STAFF REPORT
COMMUNITY DEVELOPMENT DEPARTMENT

HEARING DATE: July 1, 2021
 (Continued from: June 3, 2021)

SUBJECT: H-2021-0015
 Woodcrest Townhomes – CPAM, RZ

Amendment to the Comprehensive Plan Future Land Use Map (CPAM) to change the future land use designation on 2.10-acres of land from Commercial to Medium High-Density Residential; and Rezone (RZ) of 2.10-acres of land from the L-O (Limited Office) to the R-15 (Medium High-Density Residential) zoning district.

C. Conceptual Development Plan (NOT APPROVED)

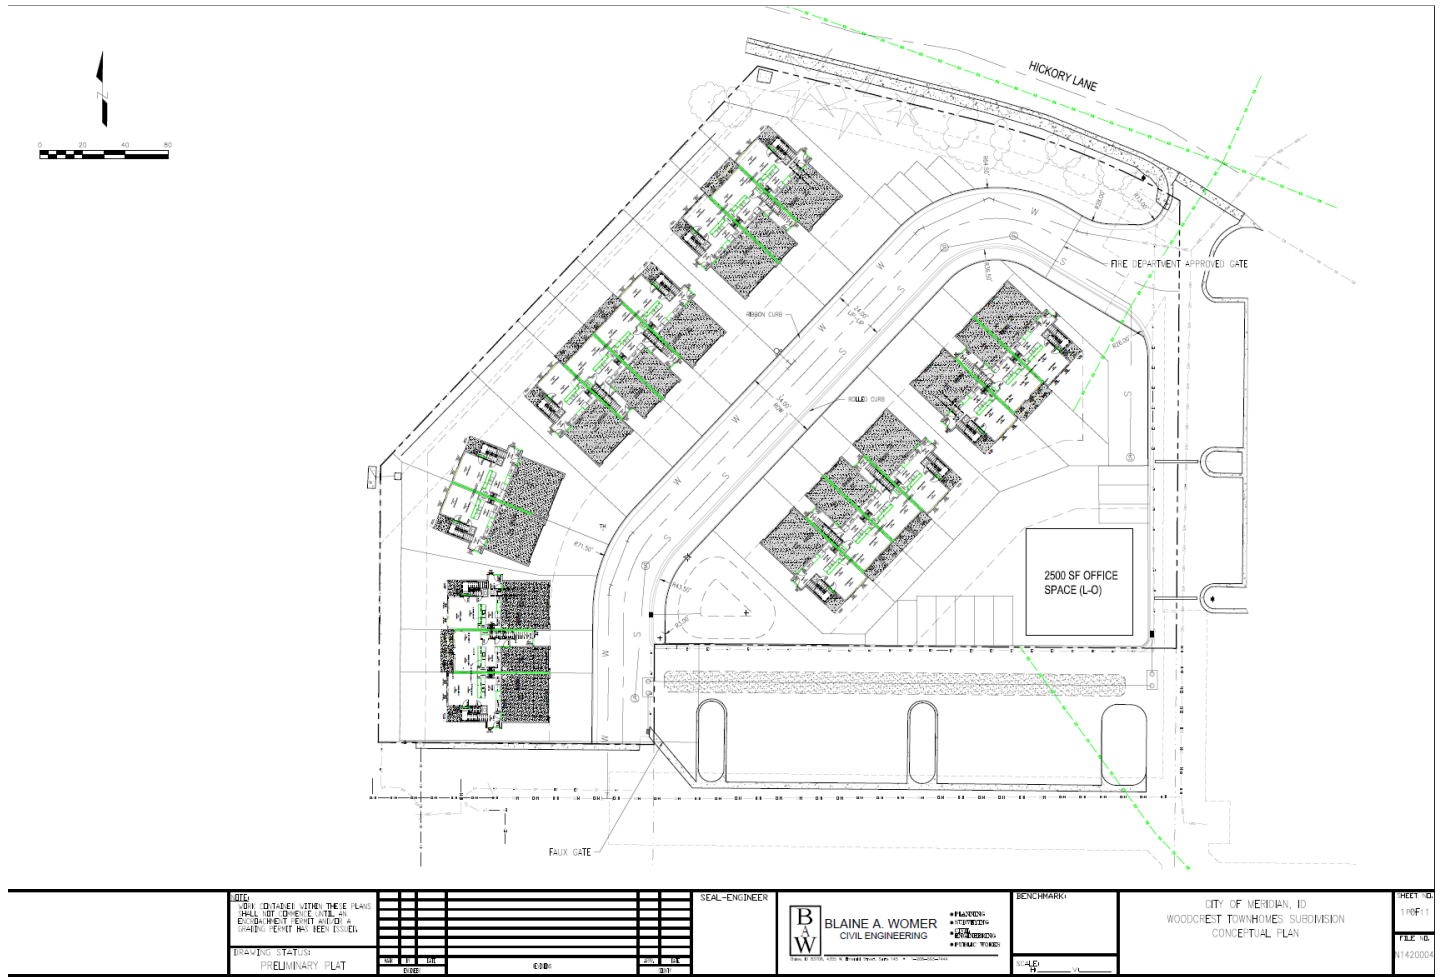
<ul style="list-style-type: none"> • Existing sewer not shown correctly. Missing existing manhole and shown as extends further into the property then existing sewer actually goes. • There is an existing 8" stub from existing manhole that looks like it will not be used. If this is the case the existing stub must be abandoned at the manhole per City Requirements. • Ensure that infiltration trenches are located so that sewer services do not pass through them.
Water	
• Distance to Services	Directly adjacent
• Pressure Zone	3
• Estimated Project Water ERU's	See application
• Water Quality Concerns	None
• Project Consistent with Water Master Plan	Yes
• Impacts/Concerns	<ul style="list-style-type: none"> • Do not have services crossing private lots

The conceptual development plan depicts access to the site via a cross-access easement from an existing driveway from N. Hickory Way, a collector street; no stub streets exist to this property. Direct access via

N. Hickory Way is prohibited. A private street is planned to provide access to the proposed development and for addressing purposes; an application for such should be submitted with the preliminary plat application and compliance with the standards listed in UDC [11-3F-4](#) is required. **Staff recommends the Applicant work with the property owner to the east to extend the private street to Hickory Way in order to better facilitate emergency access to the site for wayfinding purposes.**

A minimum of one (1) off-street parking space is required for every 500 square feet (s.f.) of gross floor area for non-residential uses (i.e. the office). Based on 2,500 s.f. for the office, a minimum of (5) spaces are required. A total of (9) spaces are proposed, exceeding the minimum standards. Most of the parking spaces for the office encroach within the required 20-foot wide buffer to residential uses, which is not allowed.

Staff Recommendation: Because this is an infill property and has an irregular configuration, development of this site is difficult. The proposed concept plan with an office at the southeast corner with parking that encroaches within the required land use buffer does not comply with UDC standards as noted above and is constricted. The Comprehensive Plan states development in MHDR designated areas should incorporate high quality architectural and site design to ensure quality of place and incorporate connectivity with adjacent uses and pathways and include attractive landscaping and a project identity. To achieve this goal and alleviate some of the spatial constrictions on the site, Staff recommends as a provision of the rezone that the office building is removed from the plan and open space with quality landscaping and some parking is provided instead with pathways along the south and east sides of the development and a gazebo with a

seating area as an amenity which can be shared between the residential and commercial development. Prior to the City Council hearing, the Applicant should revise the concept plan accordingly.

- 1.1 No Permanent structures (buildings, carports, trash receptacle walls, fences, infiltration trenches, lightpoles, etc.) can be built within the utility easement.
- 1.2 Do not have water and/or sewer services crossing private lots.
- 1.3 The existing sewer is not shown correctly. Missing existing manhole and shown as extending further into the property than existing sewer actually goes.
- 1.4 There is an existing 8" sewer stub from existing manhole that looks like it will not be used. If this is the case the existing stub must be abandoned at the manhole per City Requirements.
- 1.5 Ensure that infiltration trenches are located so that sewer services do not pass through them.

Prior to the City Council hearing, Staff recommends the conceptual development plan is revised to remove the office building and replace it with common open space with quality landscaping that incorporates the following: parking, pedestrian pathways along the south and east sides of the development, and a gazebo with a seating area which can be shared between the residential and commercial development.

- e. The subject property shall be subdivided prior to submittal of a Certificate of Zoning Compliance and Design Review application(s) for the site.
- f. The Applicant shall work with the property owner to the east to extend the private street to Hickory Way if possible in order to better facilitate emergency access to the site for wayfinding purposes.
